The Commission has issued the enclosed Amendments Nos. 66, 66 and 63 for Licenses Nos. DPR-38, DPR-47 and DPR-55 for the Oconee Nuclear Station, Units Nos. 1, 2 and 3. These amendments consist of changes to the Station's common Technical Specifications and are in response to your request dated September 18, 1978, as supplemented September 25, and November 1, 1978.

These amendments revise the Technical Specifications to support the operation of Oconee Unit No. 2 at full rated power during Cycle 4 after core reload and removal of the orifice rod assemblies from the core. The amendments also revise the Technical Specifications for Units 1, 2 and 3 in regard to control rod operability.

ATTACHMENTS TO LICENSE AMENDMENTS

2.1-3a & 2.1-3b  
2.1-8 (Figure 2.1-2B)  
2.3-9 (Figure 2.3-2B)  
3.2-1 & 3.2-2  
3.5-5 - 3.5-11  
3.5-11a & 3.5-11b  
3.5-11c\* (Table 3.5-1)  
3.5-14 (Figure 3.5.2-1B1)  
3.5-14a (Figure 3.5.2-1B2)  
3.5-15  
3.5-19 (Figure 3.5.2-2B1)  
3.5-19a (Figure 3.5.2-2B2)  
3.5-19b  
3.5-22 (Figure 3.5.2-3B1)  
3.5-22a (Figure 3.5.2-3B2)  
3.5-22b  
3.5-23f (Figure 3.5.2-4B1)  
3.5-23g (Figure 3.5.2-4B2)  
3.5-23h  
4.1-9

OCONEE NUCLEAR STATION  
Figure 2.1-2B

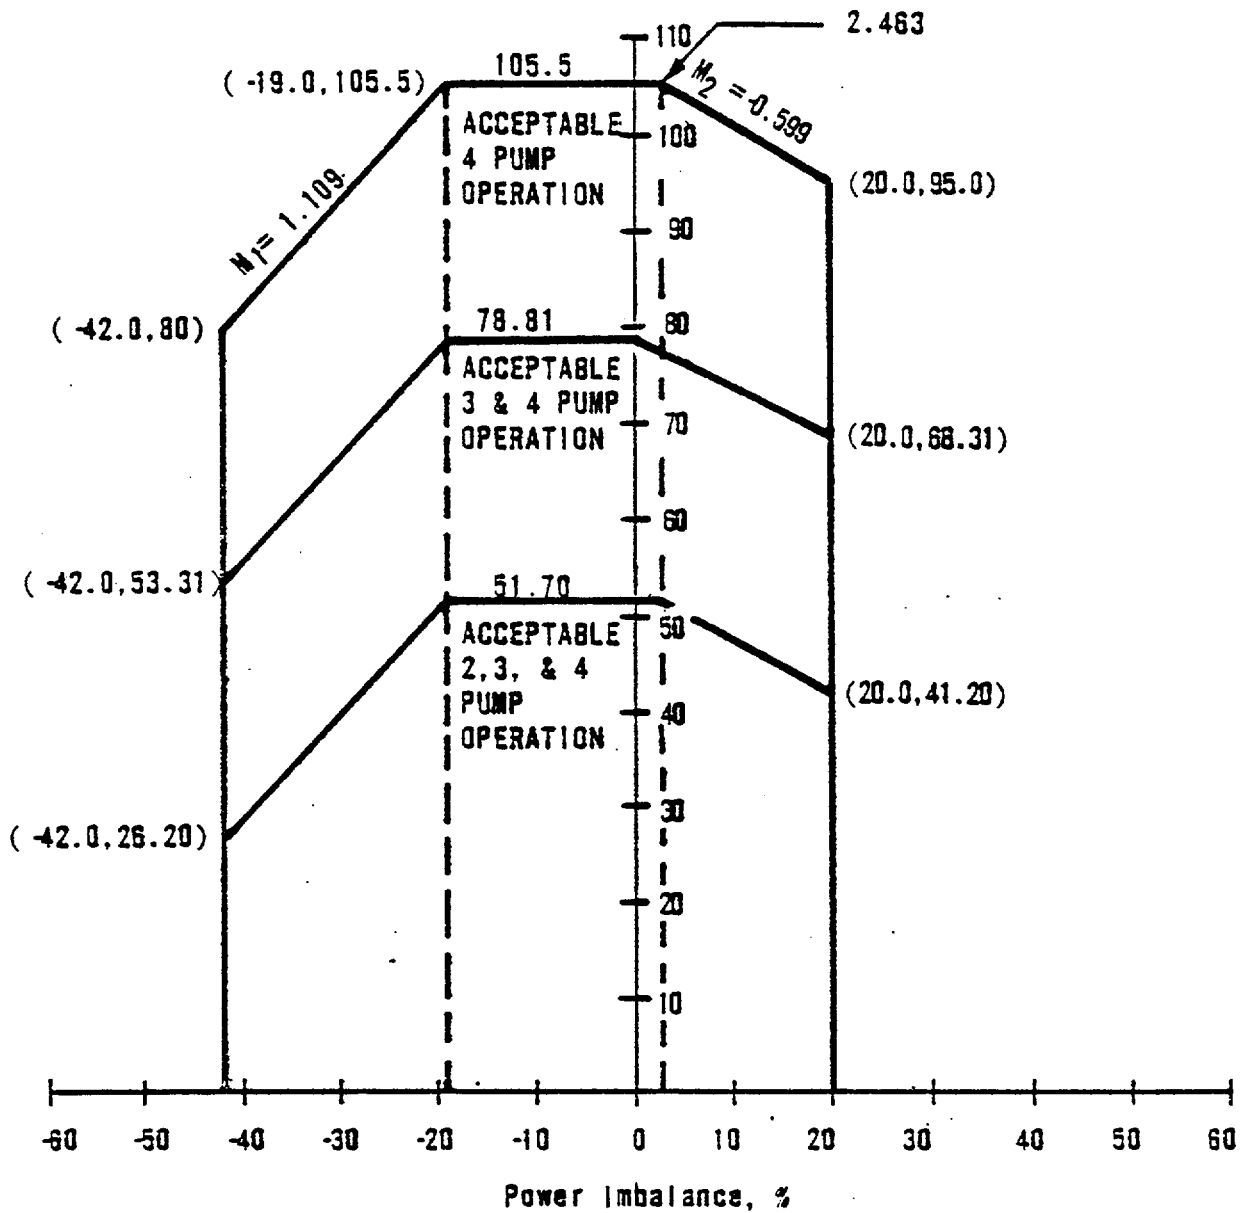
The curves of Figure 2.1-2B are based on the more restrictive of two thermal limits and include the effects of potential fuel densification and fuel rod bowing:

1. Modification to Core Protection Safety Limits  
(Figure 2.1-2B)\*
2. Modification to Protective System Maximum Allowable Setpoints  
(Figure 2.3-2B)
3. Modifications to Rod Position Limits  
(Figures 3.5.2-1B1, 1B2, 2B1, and 2B2)
4. Modifications to Operational Power Imbalance Envelope  
(Figures 3.5.2-3B1 and 3B2)
5. Modifications to APSR Position Limits  
(Figures 3.5.2-4B1 and 4B2)
6. Reduction in  $F\Delta H$  from 1.78 to 1.71
7. Increase in the allowed steady state quadrant tilt to 5%  
and in the linear heat rate peaking increase associated  
with positive tilt to 7.50%.
